Access Compliance Report

Public Rights-of-Way

(Curb Ramps)

| Intersection ID: 12998 | Main Street: E_5TH_ST | Cross Street: N_MCDOWELL_ST | Location: W |

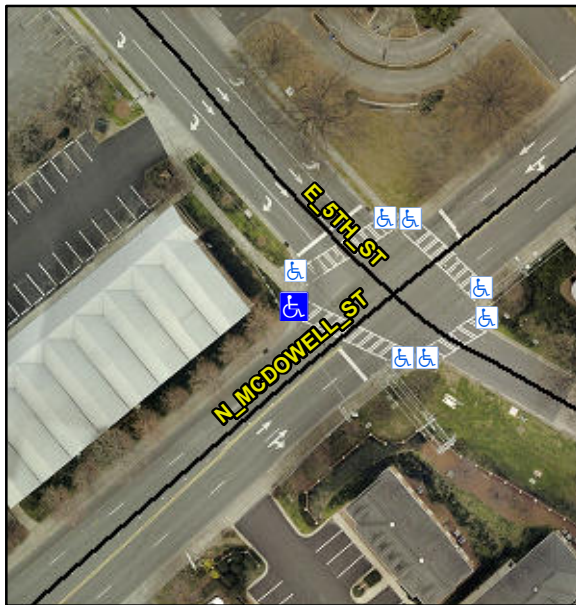
| ADA ID: 93371C8F026D | Ramp Type: Combination2 | Initial Pass/Fail: Fail | Overall Compliance: No |

Not Found, R304.3.2, R304.5.3

| Compliance | Description | Data | Compliance | Description | Data |
|------------|-----------------------|-------|------------|-----------------------------|------|
| N/A | Ramp Slope LT (%) | N/A | No | Ramp Slope RT (%) | 9.0 |
| N/A | Ramp XSlope LT (%) | N/A | No | Ramp XSlope RT (%) | 3.5 |

Remove & Replace Entire Ramp.
